IOWA COLONY PLANNING COMMISSION
MINUTES OF MARCH 2, 2021

LETTER OF RECOMMENDATION

STERLING LAKES AT IOWA COLONY AND SIERRA VISTA PLAN OF DEVELOPMENT AMENDMENT #2

FIGURE 1A

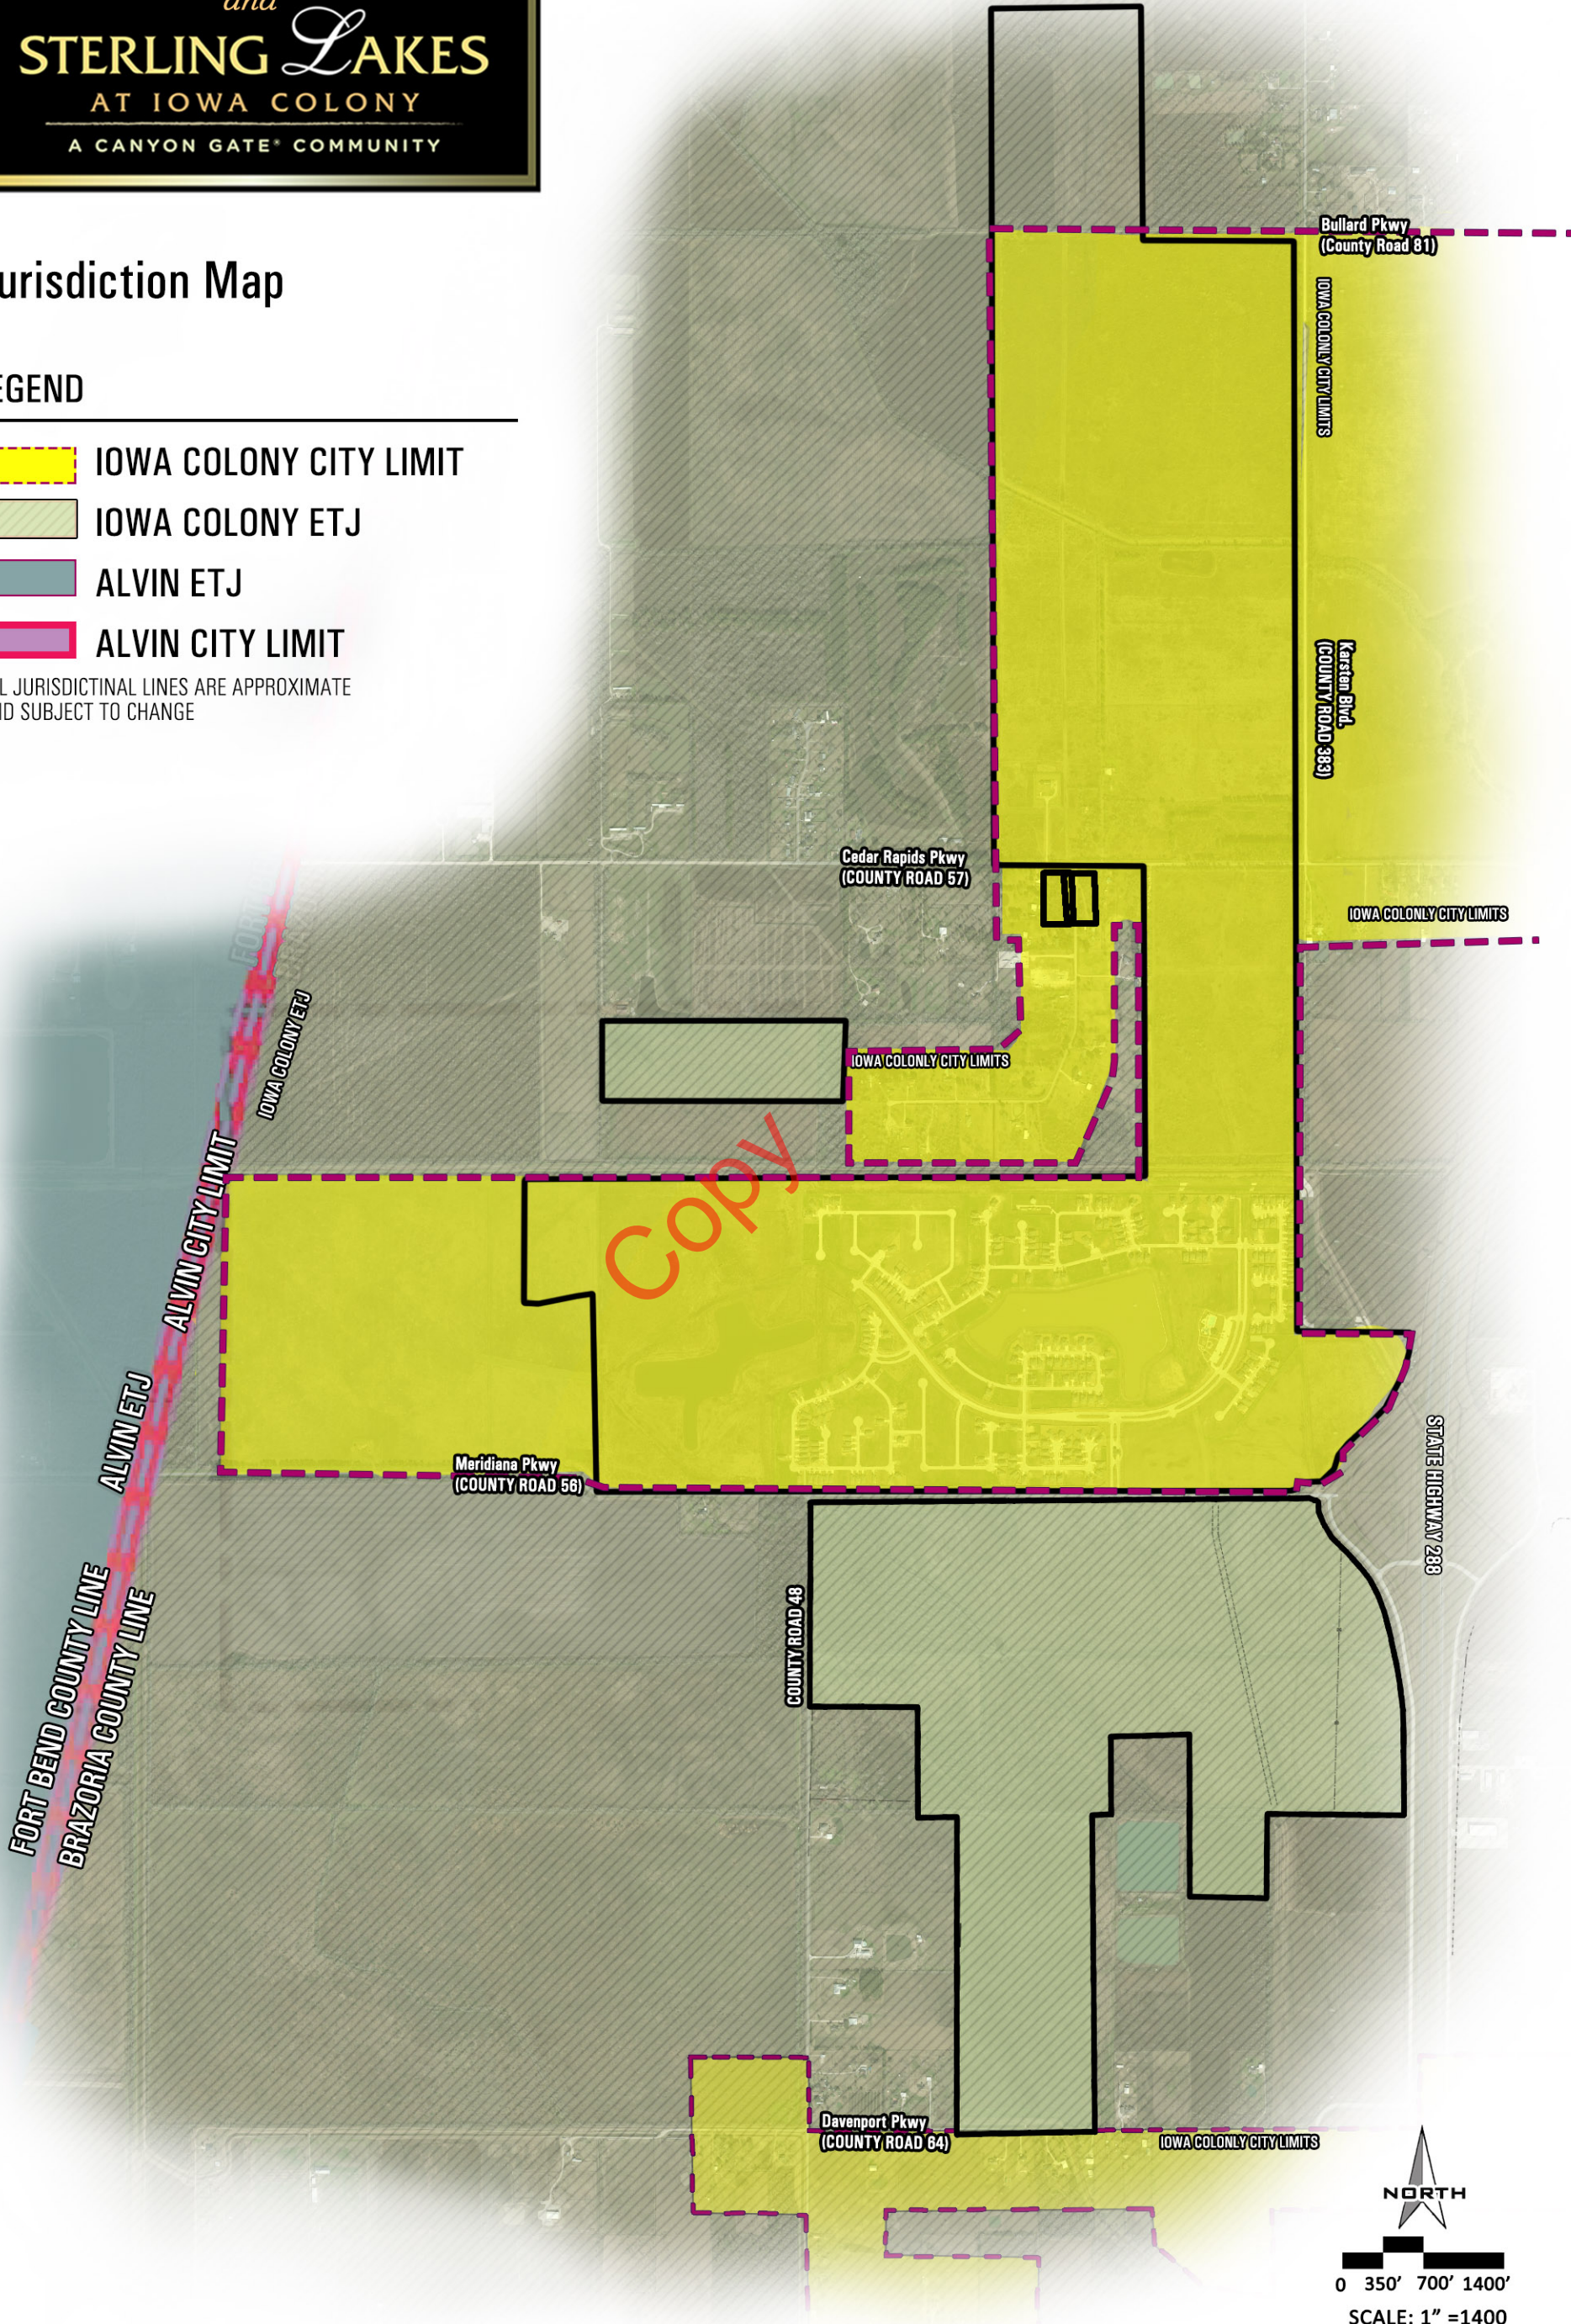
Figure 1A Jurisdiction Map – Correct map to indicate the area north of Bullard Parkway as within the ETJ if the area south of Bullard Parkway is within the city limit

FIGURE 2

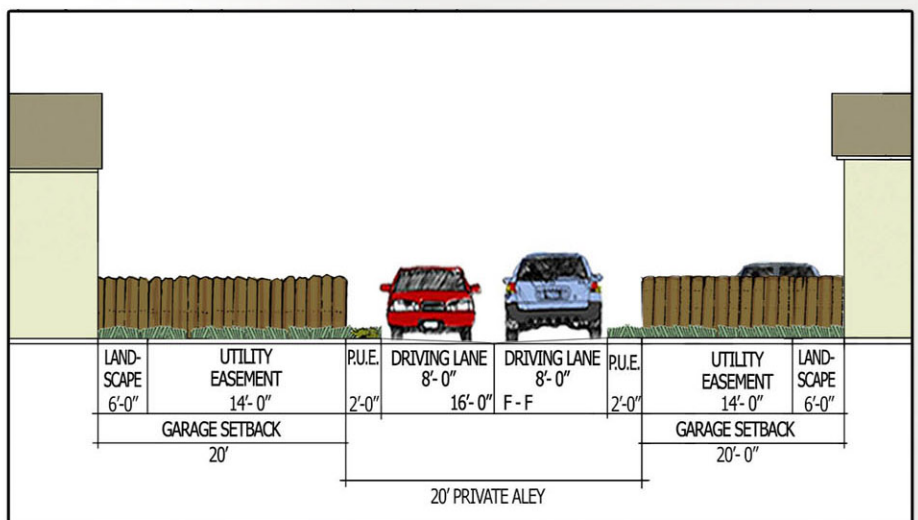
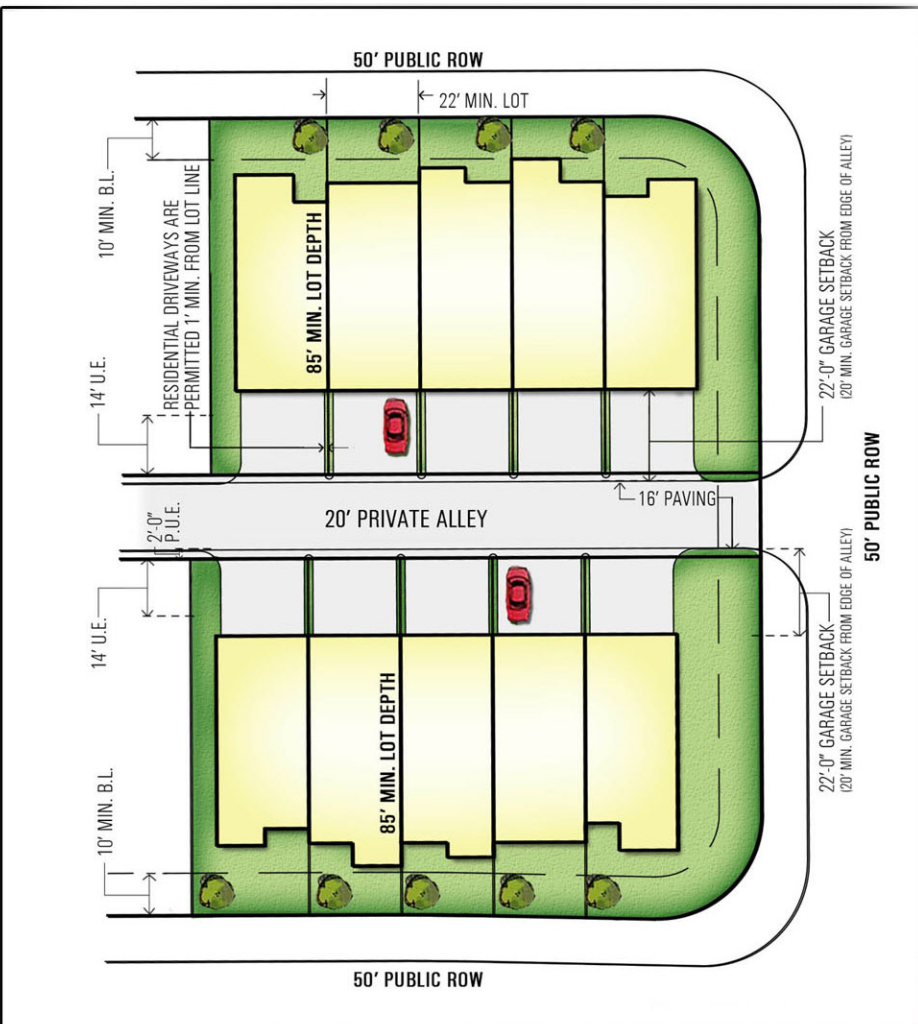
Figure 2 General Development Plan – Add the total acreage of the Plan of Development on this exhibit and indicate why the current platted/existing lot count for Type #1 lots exceeds the maximum allowed of 65% (the numbers add up to 68%)

FIGURE 2a

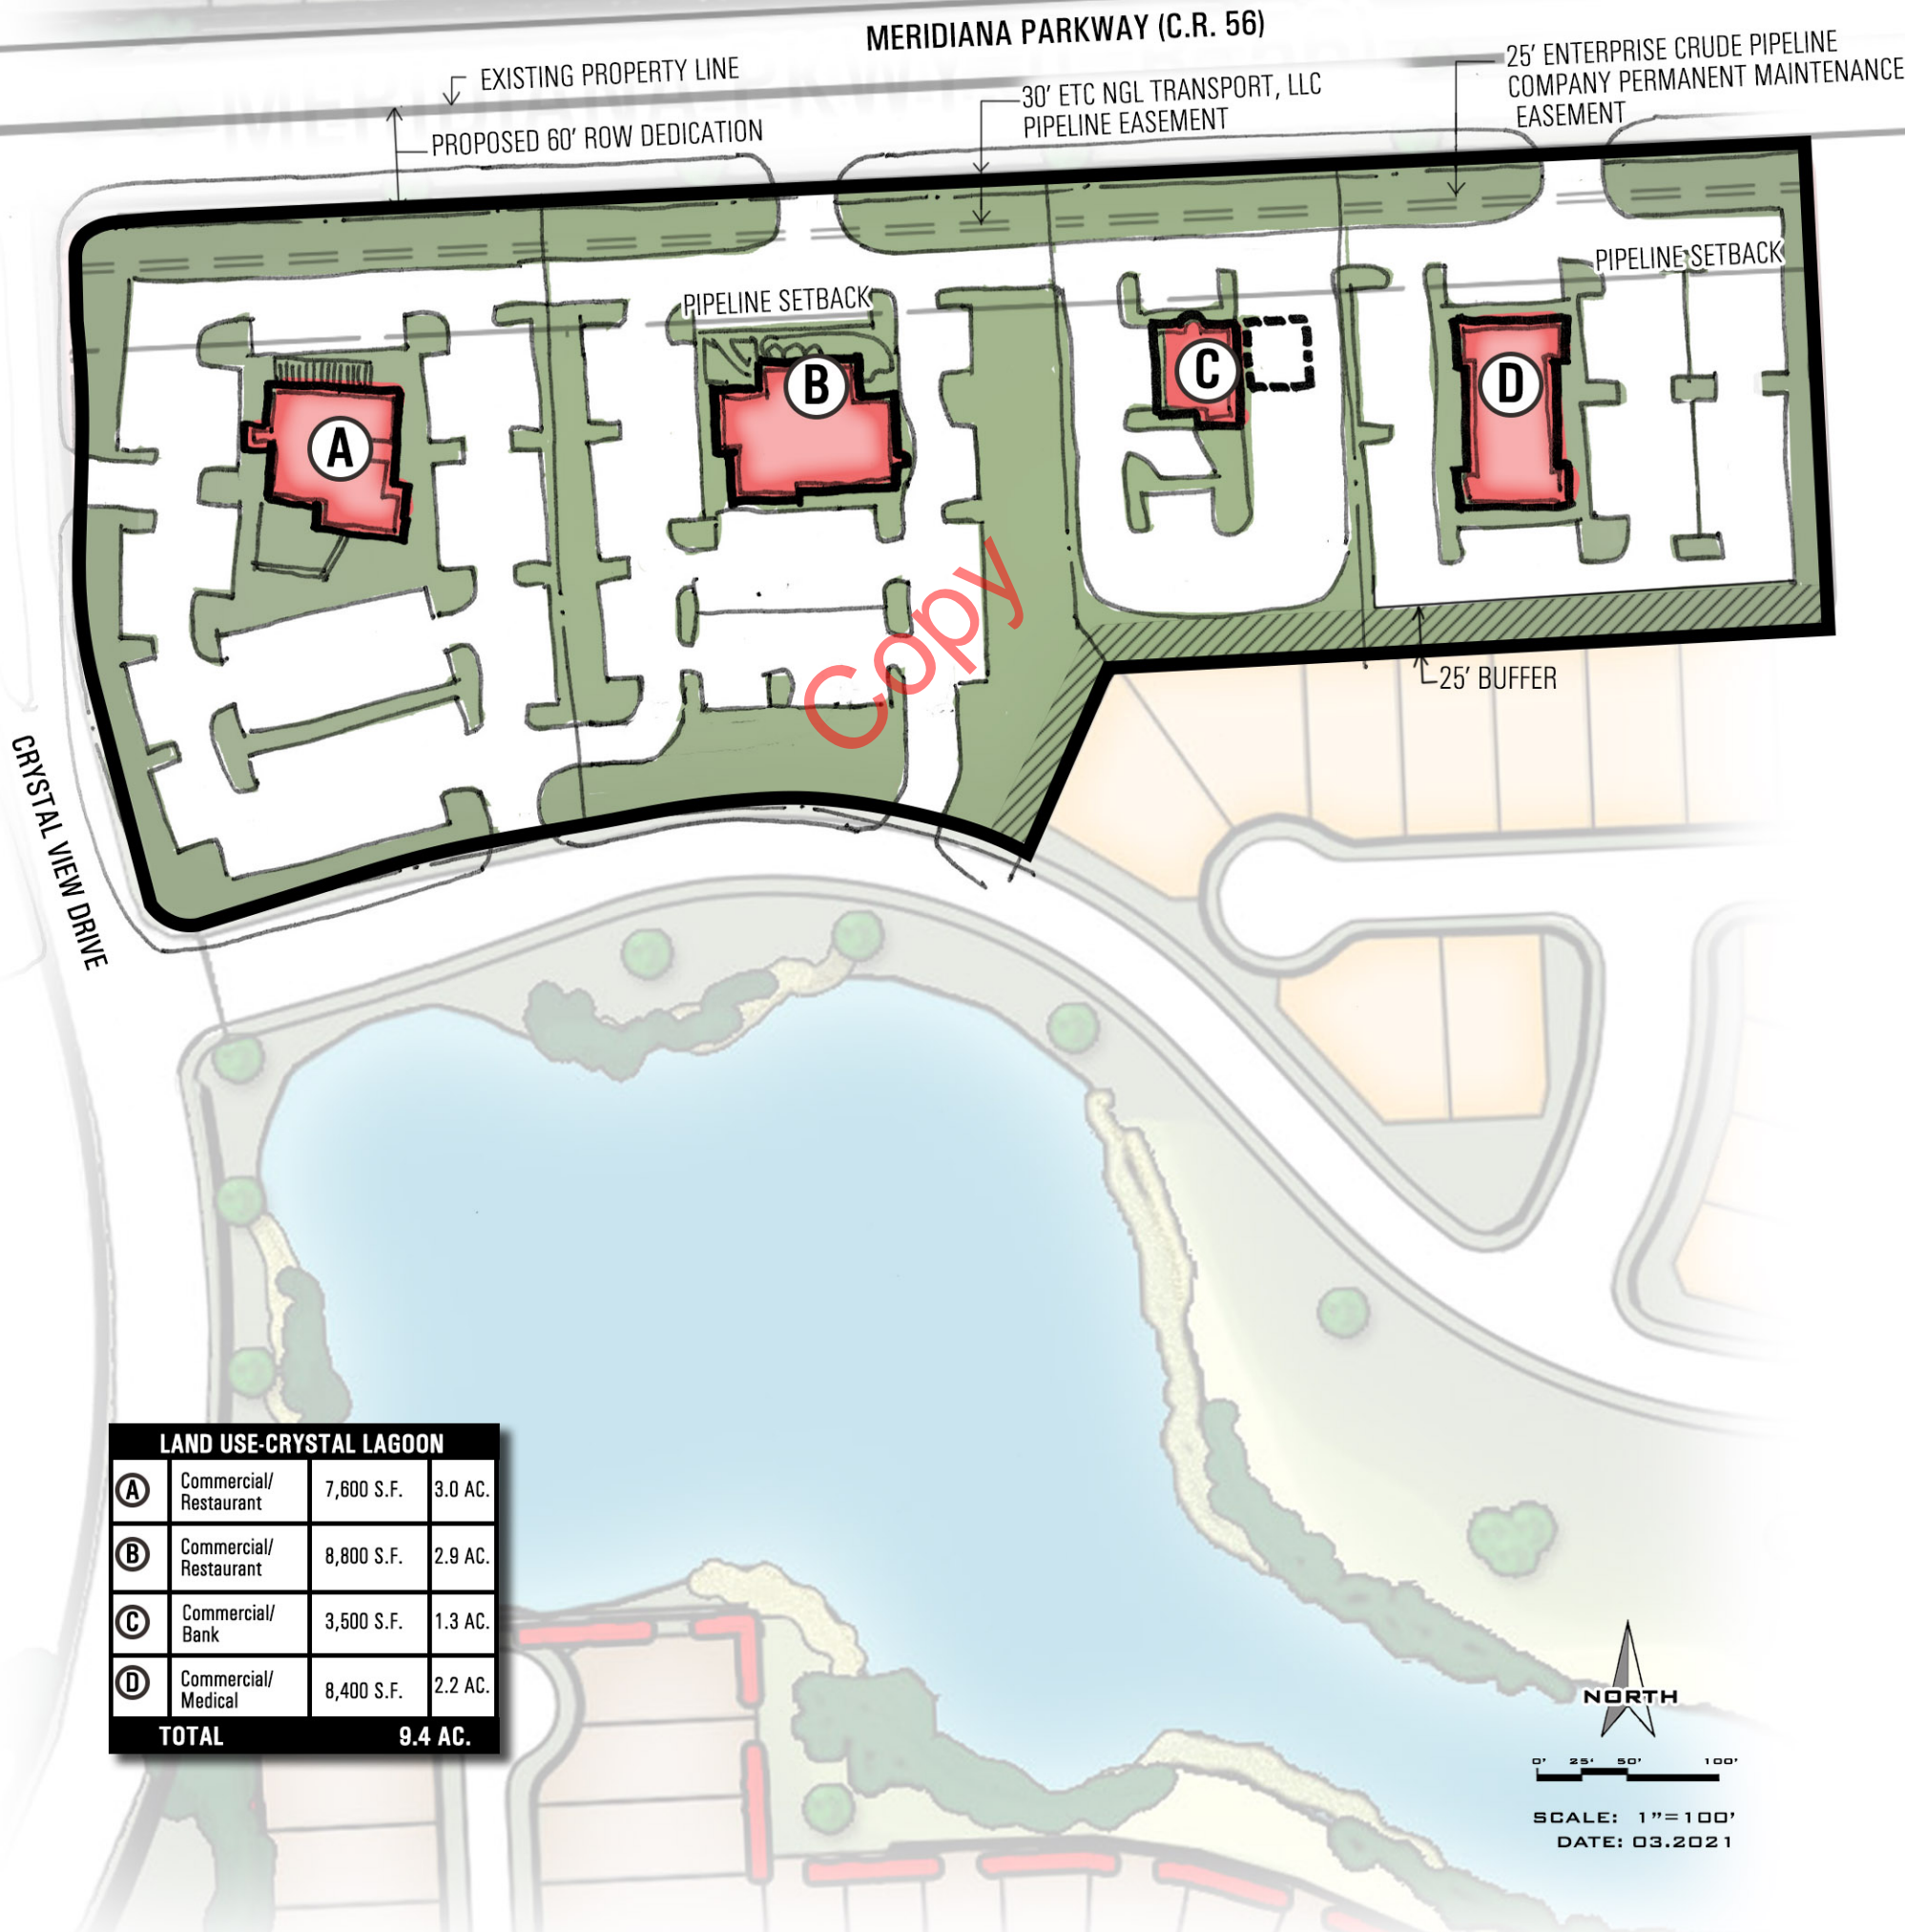
Figure 2a - Indicate the Build-to line along Meridiana Parkway. Remove individual lot line designations in the townhouse area
